**Lockport-Batavia Line #112  
Rebuild Project**

**EM&CP Update**

**Replacement Sheets  
CP-04A, 13, CP-67, and CP-68  
in  
Appendix Y  
(Culvert Drawings)**

*(Revised January 2026; Replaces Version Filed June 2025)*

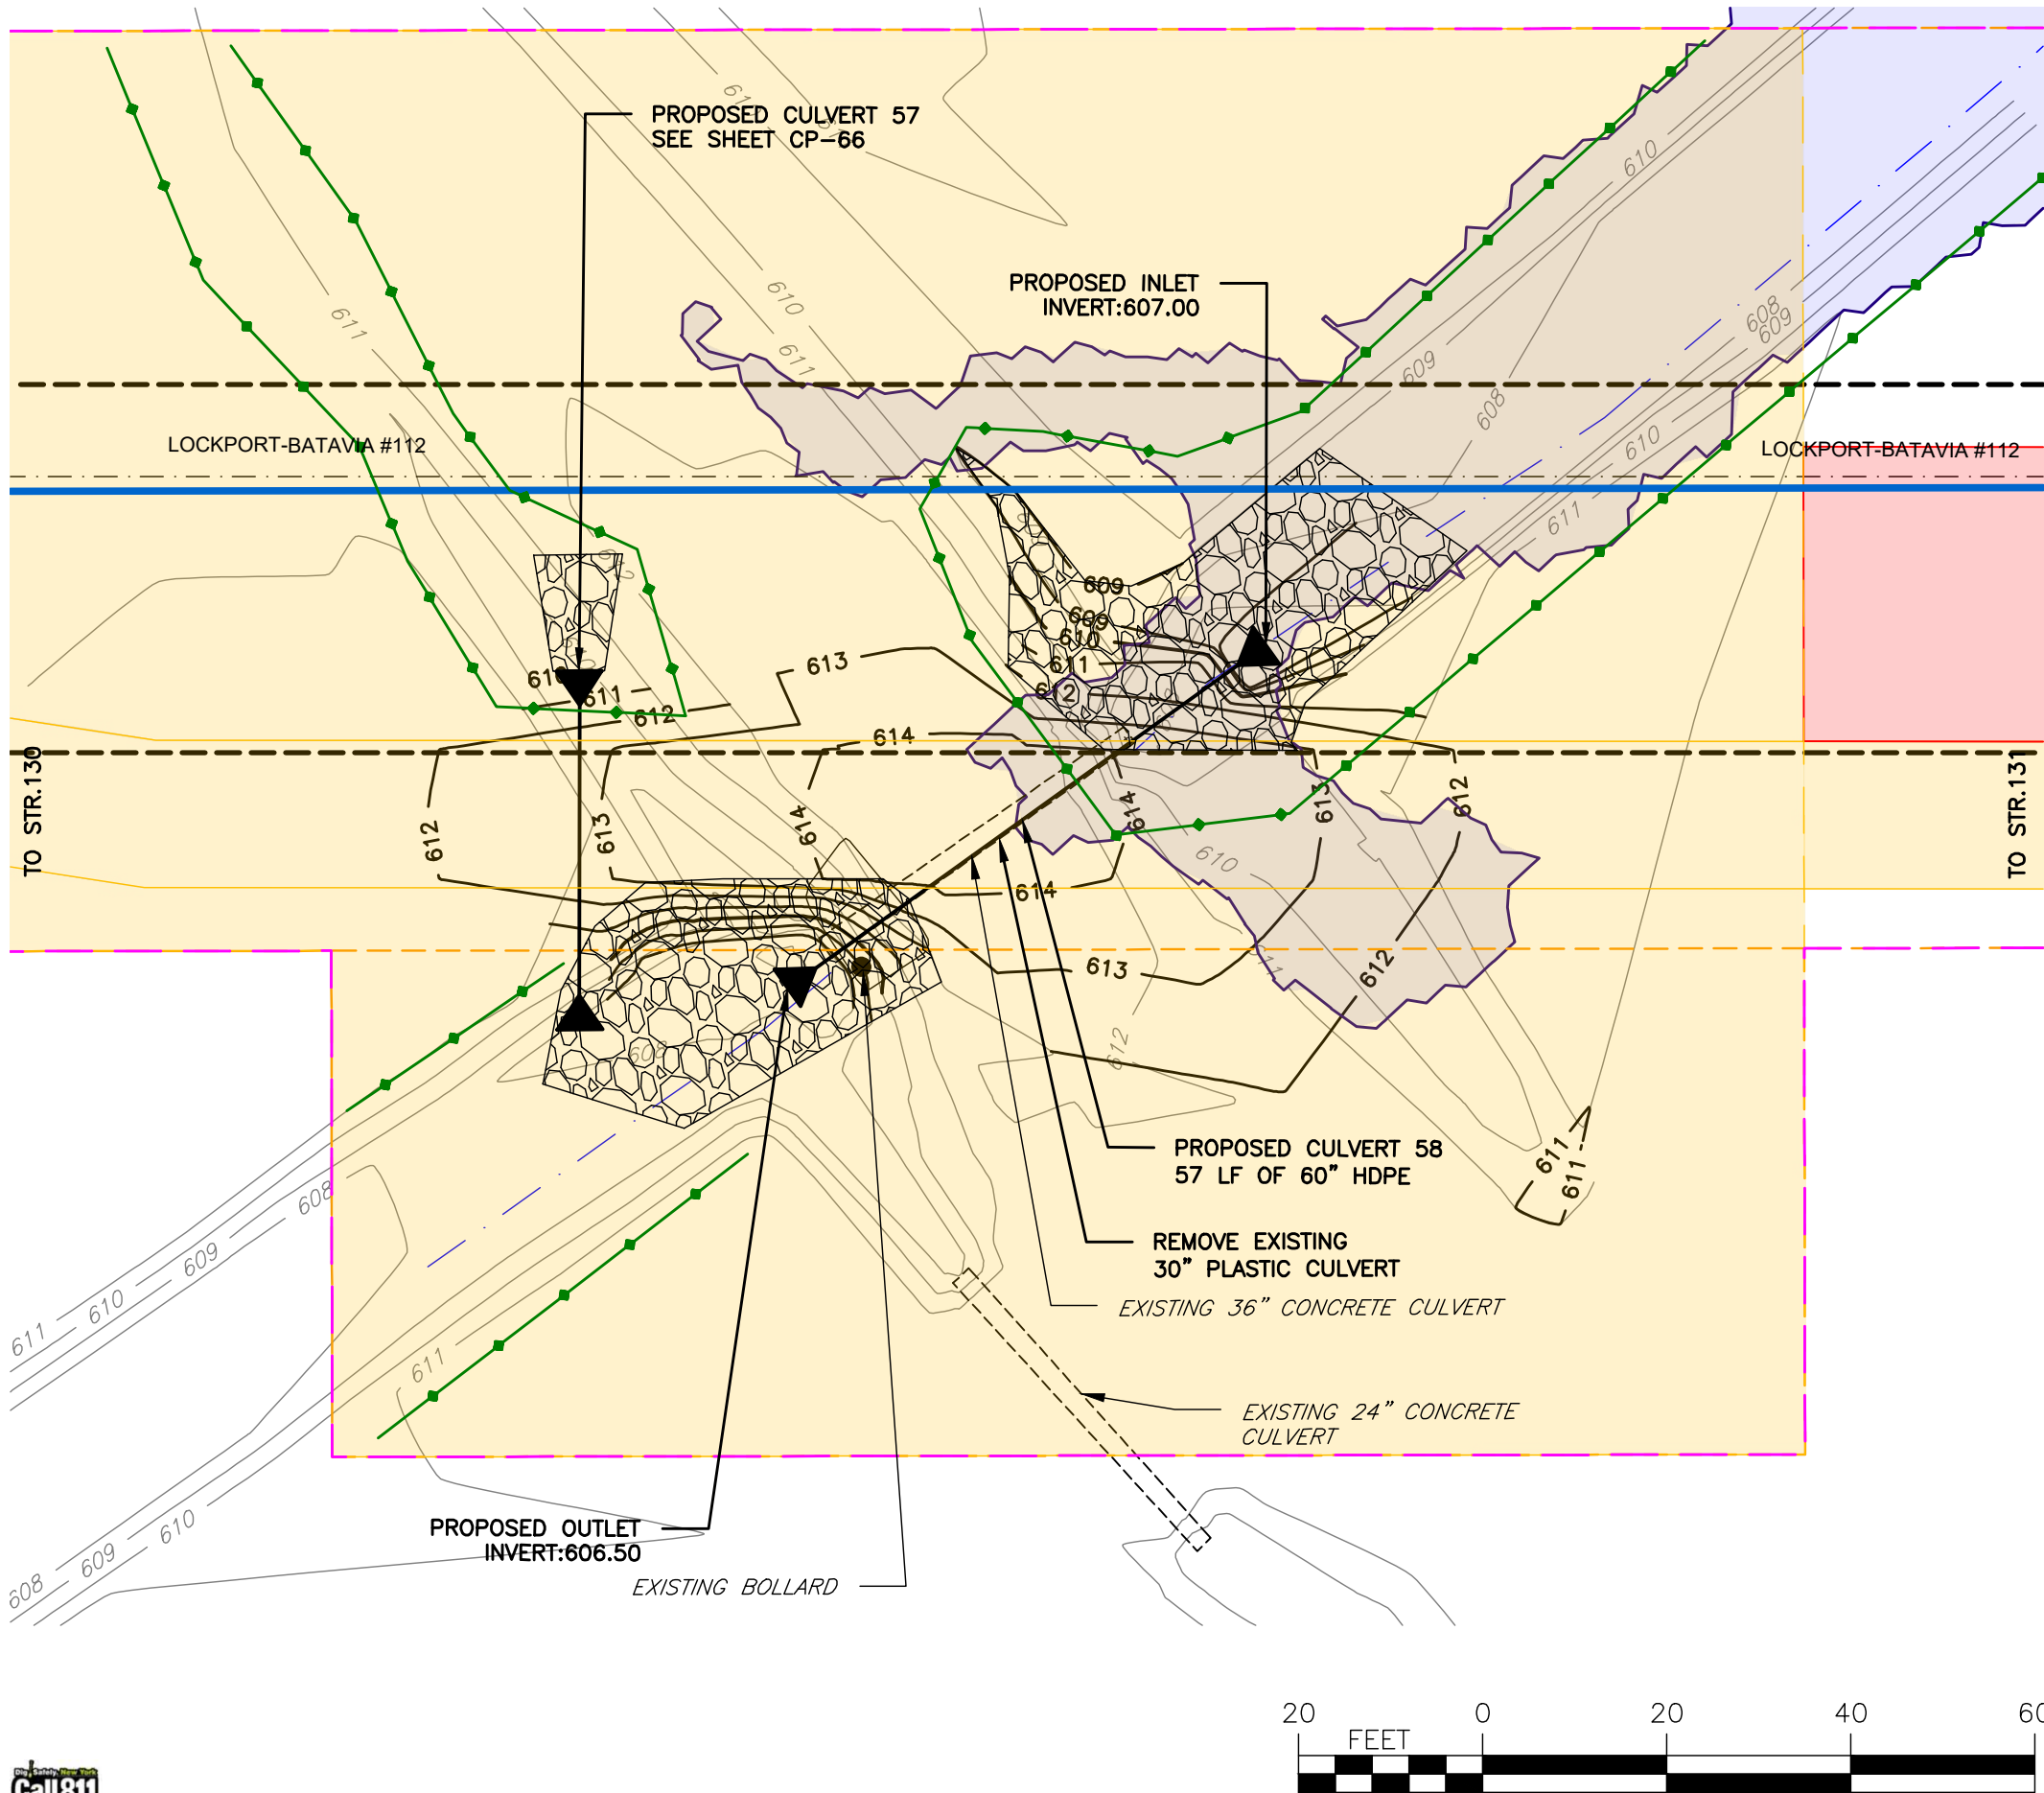
nationalgrid										PREPARED BY			
								DES		H.P		APPROVED		FISHER		CULVERT PLAN		ORIGINAL ISSUE DATE		6/06/25			
								DR		APPROVED						LOCKPORT-BATAVIA 112		FILE INDEX		6.1-L10-M5			
								CK		RW/VL		APPROVED				REBUILD PROJECT		DRAWING NUMBER		L1-41568			
1		1/2026				TJL		SM		TL		APPROVED		RW/VL		NYSDEC STREAM 010 CROSSING CULVERT		SHEET NUMBER		CP-67			
NO.		DATE		AGENCY COMMENTS		TJL		DR		CK		APP.		APPROVED									
				DESCRIPTION OF ISSUE OR REVISION
